SERVICE BULLETIN

INSPECTION OF THE OIL FILTER

PART NO. 825701

FOR ROTAX® ENGINE TYPE 912 AND 914 (SERIES)

(see fig. 1)

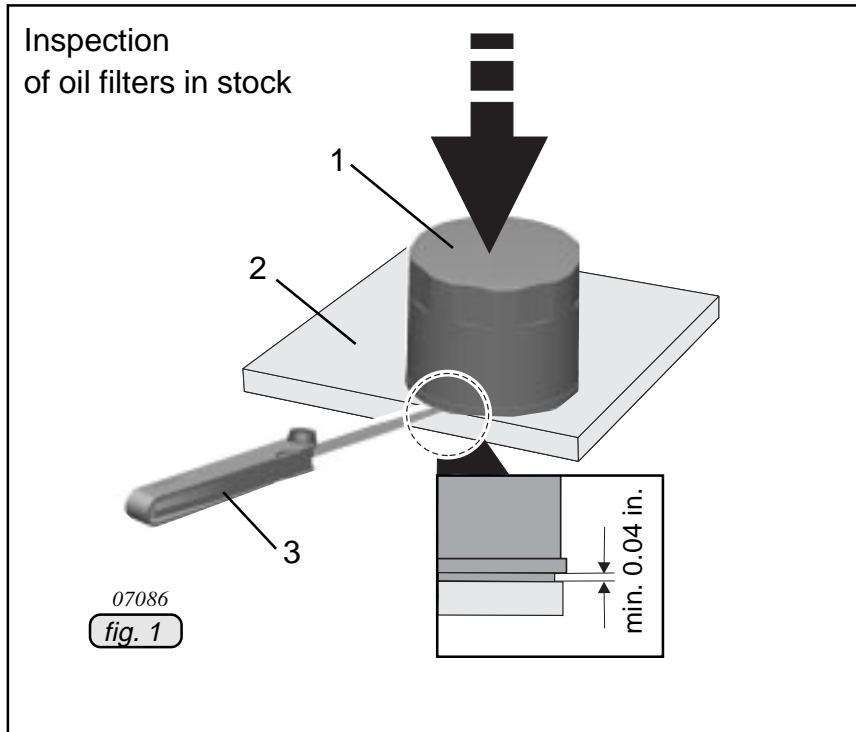
3.1) Inspection of oil filter part no. 825701 in stock

- Place oil filter (1) on an even base plate (2).
- Press down oil filter by thumb in order to fully fit sealing ring into its groove.
- With pressure still applied measure the projection of sealing ring (in this case the gap between base plate and oil filter bead) with a feeler gage (3). If the projection is smaller than **1,0 mm** (0.04 in.), otherwise replace the oil filter immediately.

(see fig. 2)

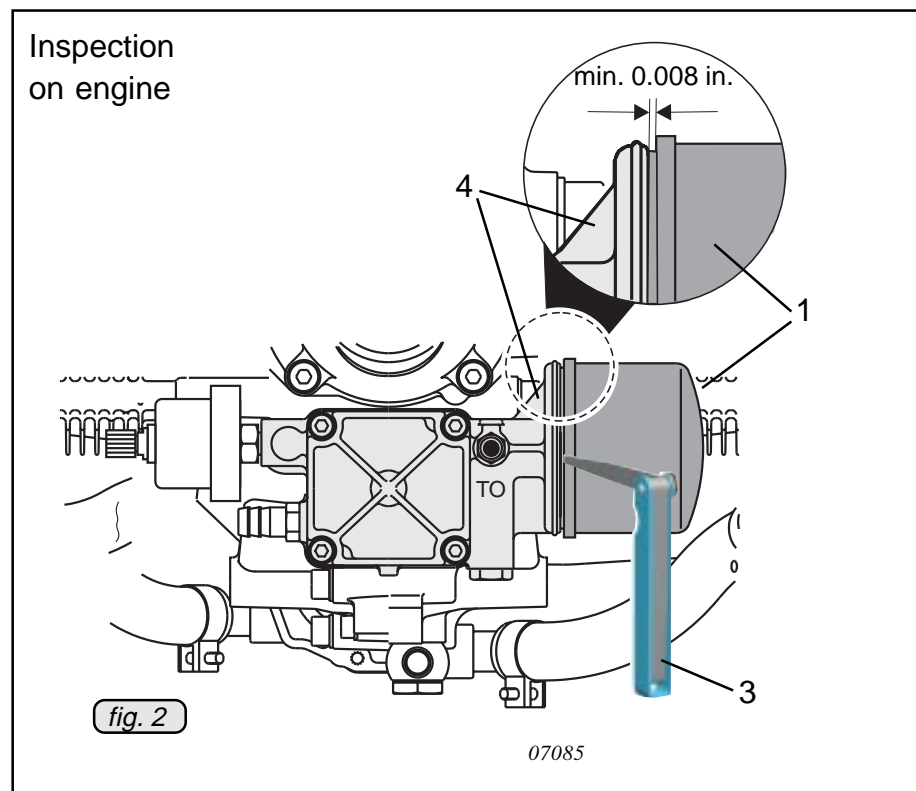
3.2) Inspection of oil filter part no. 825701 installed on engine

- Measure the projection of sealing ring (in this case the gap between oil pump housing and oil filter bead) with a feeler gage (3).

If the projection is smaller than **0,2 mm** (0.008 in.), replace the oil filter immediately.
